PLANNING BOARD

To: Brookline Board of Appeals
From: Brookline Planning Board
Date: March 31, 2016
Subject: Convert existing three-family dwelling into a four-family dwelling and install three additional off-street parking spaces
Location: 21 Kent Street

Atlas Sheet:	30	Case #:	2016-0009
Block:	140	Zoning:	G-2.0
Lot:	15	Lot Area (s.f.):	±5,703

2 LANDSCAPE CONCEPT OPTION 2
SCALE: 1/8" = 1'-0"

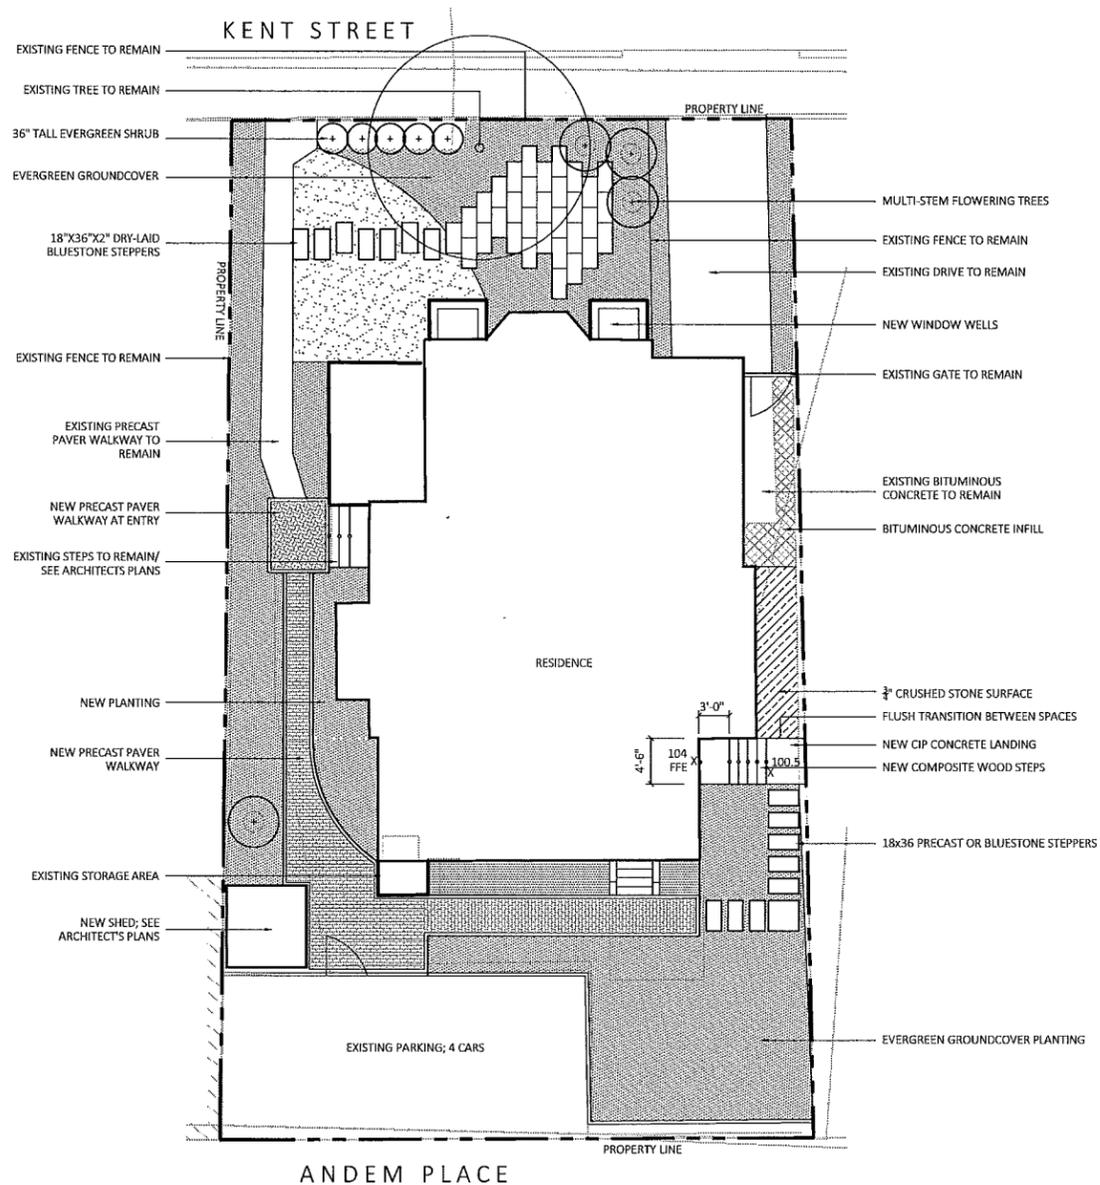
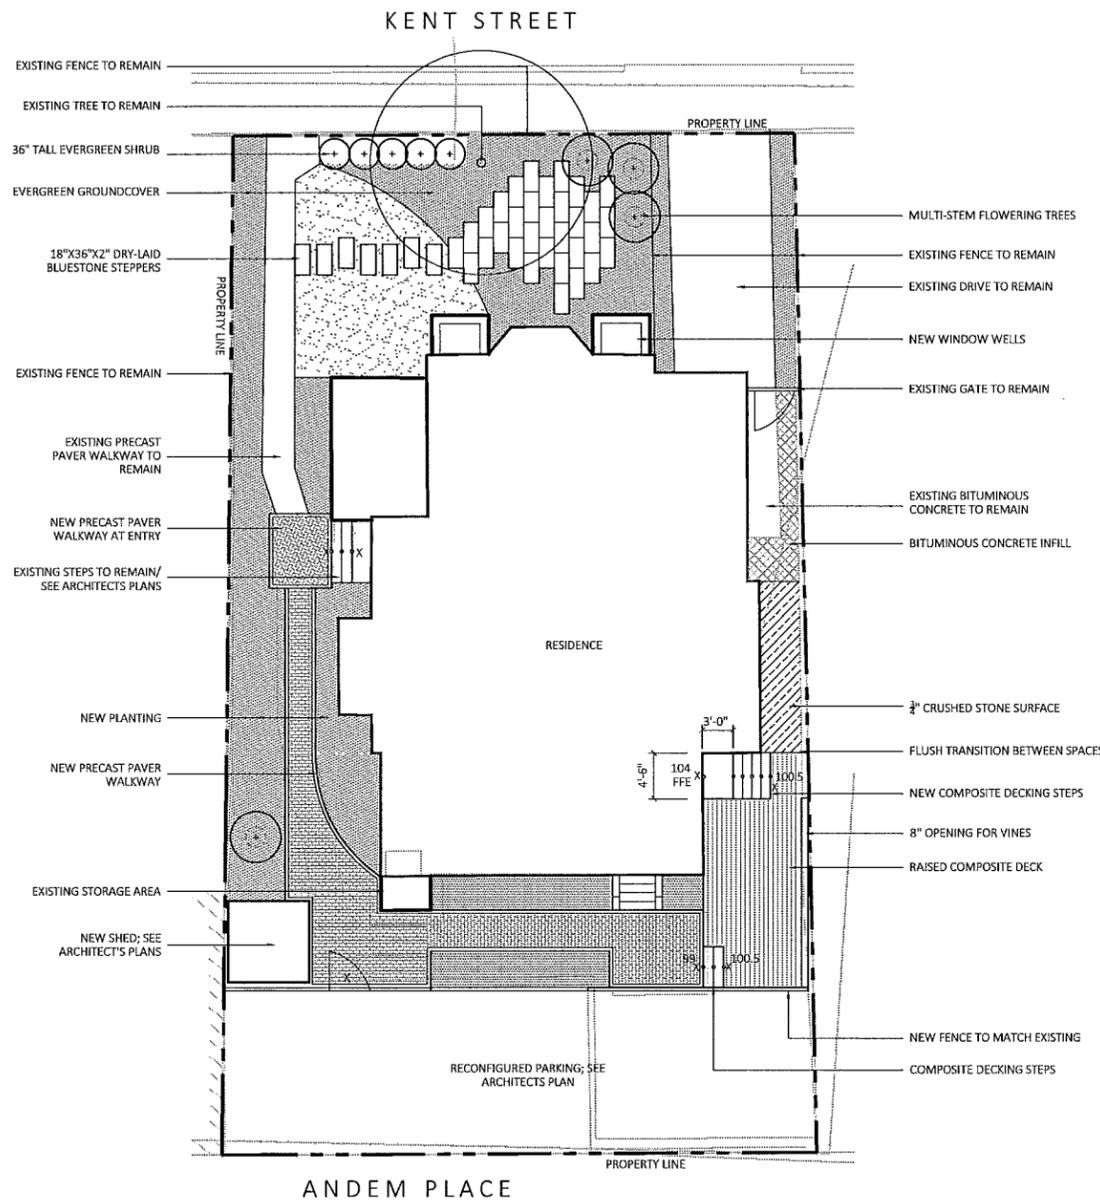
Submitted landscape concept plans include options for either precast steppers or a raised composite deck (21.6' x 10') between the Andem Place parking area and rear access points to the structure. The steppers option does not alter the side yard setback in this area but any raised deck that requires the installation of footings would further reduce the side yard setback along the eastern lot line to 7.2 inches.

The plans show Option 1 and Option 2; however, only Option 2 is proposed by the applicant.

- d. Open Space – The applicant has submitted two landscaping concepts that do encourage more interaction and active use of front and side yard areas. The reconfigured open space along Kent Street is attractive and must be continuously maintained, however the elimination of evergreen ground cover along Andem Place does result in the loss of visual amenity for surrounding properties and will adversely affect water runoff and drainage.

The Planning Board is not opposed to the creation of a fourth residential unit at the basement level. This proposed floor area increase requires limited exterior alterations to the structure itself. The surrounding neighborhood, particularly along Andem Place, includes a variety of dense impervious parking surfaces. The Board recommends six not seven parking spaces along Andem Place and retaining the existing parking space in the Kent Street front yard for a total of seven spaces on the site. Although this is one less space than the eight spaces required, under Section 5.07 parking requirements for this district can be waived up to 50%). Eliminating one of the proposed parking spaces will improve the setbacks to the parking. In addition, this area overlooks an alley and gets little sunlight, so the loss of open space is not critical.

The Board is supportive of proposed landscaping features in the front-yard to serve as a counterbalancing amenity for request setback relief. Additionally, the Board supports the maintenance and installation of solid board fences to screen residential units from vehicle headlights.

- 2. Prior to the issuance of a building permit, the applicant shall submit a final landscaping plan including all counterbalancing amenities and fencing, subject to review and Approval by the Assistant Director for Regulatory Planning.**
